From: Jessica Crighton [REDACTED]
Sent: 19 August 2026 13:24
To: Peter Bull [REDACTED]
Subject: 26/01528/S106

Comment about Accessible W/C in allotments

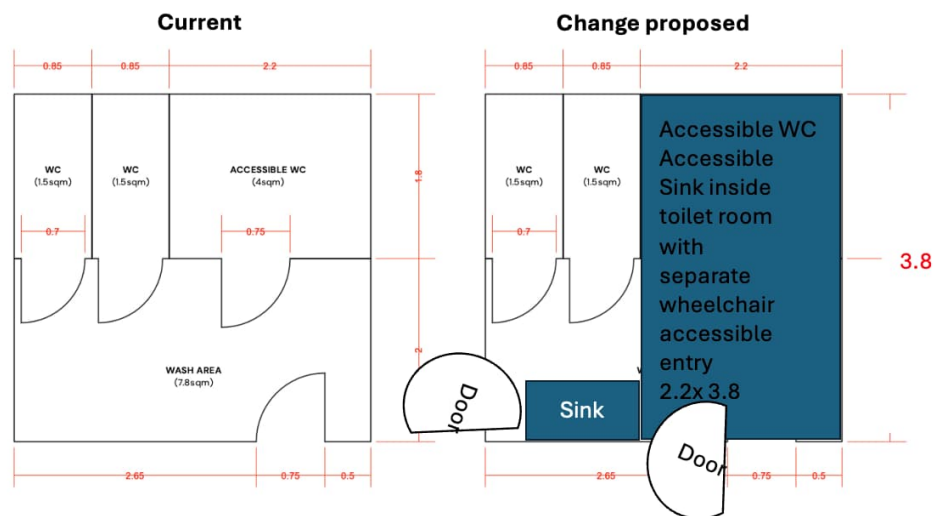
I believe the accessible toilet should have its own externally accessible door entry and accessible sink inside the toilet room.

I have mocked up how I believe the existing proposal could be changed to improve the accessible toilet - the accessible toilet could be made bigger by expanding into the currently proposed wash area.

The government's guidance says the wheelchair-accessible toilet should be positioned so that it can be accessed from a primary circulation route without requiring a disabled person or carer to pass through the single-sex toilets.

Approved Document M says the minimum overall dimensions and arrangement of fittings in a wheelchair-accessible unisex toilet must comply with Diagram 18. It also requires consideration of transfer arrangements, circulation, grab rails, accessible fittings and an emergency assistance alarm. I don't believe the current proposal with accessible toilet does that.

1.8 m is an unnecessarily restrictive depth for a new-build accessible facility and the 1.8 m depth gives the designer very little flexibility to provide a genuinely usable facility. This is a new building, not an existing building being adapted. There is therefore a much stronger case for getting the geometry right at the design stage rather than designing to the tightest possible footprint.

I believe to discharge the duty properly they need to Please provide the dimensioned layout demonstrating compliance with Diagram 18 of Approved Document M Volume 2, including the required wheelchair transfer and manoeuvring spaces.

Not every wheelchair is the same size, and some users require more space for positioning and transferring. Approved Document M itself points to BS 8300 for more detailed guidance on wheelchair transfer techniques and appropriate sanitary fittings. The design should not be so tight that it only works for a narrow range of users. Fixing this issue now at the design stage helps avoid costs of trying to rectify an inadequate facility later. The council should have them demonstrate that the proposed layout provides sufficient usable space for the disabled user and an assisting person where necessary, rather than merely demonstrating that the fittings physically fit.
